## Market Rule Amendment Proposal

Identification No.:	MR-00246-R00		
Subject:	Market Evolution Program		
Title:	Multi-Interval Optimization – Changes to Dispatch Algorithm		
Nature of Proposal:	<input checked="" type="checkbox"/> Alteration	<input type="checkbox"/> Deletion	<input type="checkbox"/> Addition
Chapter:	7.0	Appendix:	7.5
Sections:	2.2		
Sub-sections proposed for amending:	2.2.1.10A (new), 2.2.1.11, 2.2.1.15

Identification No.:	MR-00246-R01		
Subject:	Market Evolution Program		
Title:	Multi-Interval Optimization – Changes to Dispatch Algorithm		
Nature of Proposal:	<input checked="" type="checkbox"/> Alteration	<input type="checkbox"/> Deletion	<input type="checkbox"/> Addition
Chapter:	7.0	Appendix:	7.5
Sections:	2.3		
Sub-sections proposed for amending:	2.3.3 (new)

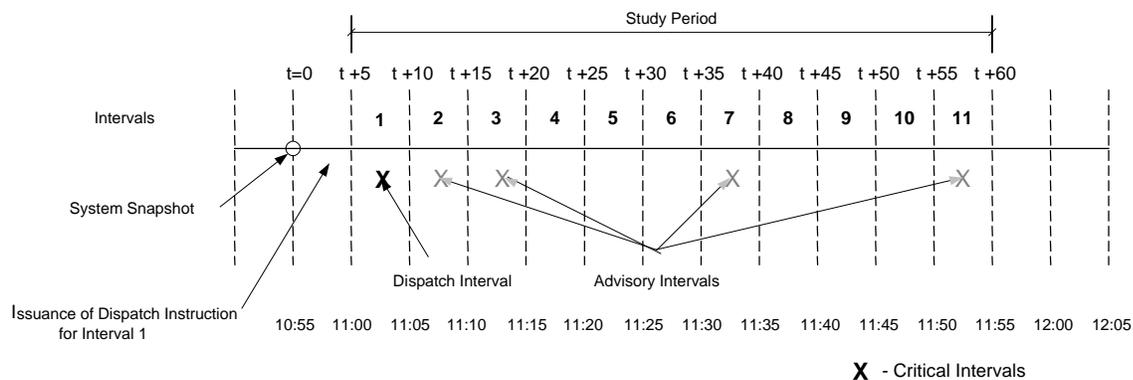
MR-00246-R01 proposes to amend section 2.3 of Appendix 7.5 by inserting a new subsection 2.3.3. Section 2.3 deals with the Optimisation Objective. The proposed new section would specify that MIO would only be used in the real time constrained schedule and describes the objective function for the real time constrained dispatch schedule which would use the weighted sum of the economic gain from trade among market participants for the dispatch interval and the advisory intervals within the study period.

A visual representation of study period, critical intervals, and advisory intervals is provided below:

2.3.3 In respect of the *real time constrained dispatch* schedule only, the *dispatch scheduling and optimization* process shall have as its objective function maximizing the weighted sum of the economic gain from trade among *market participants*, as described in section 4.3.2 and 4.3.3 of Chapter 7, for the *dispatch interval* and for advisory intervals within the study period. Critical intervals are those selected from the study period to be used as input to the objective function. The first critical interval is always the *dispatch interval*. The remaining critical intervals are advisory intervals.
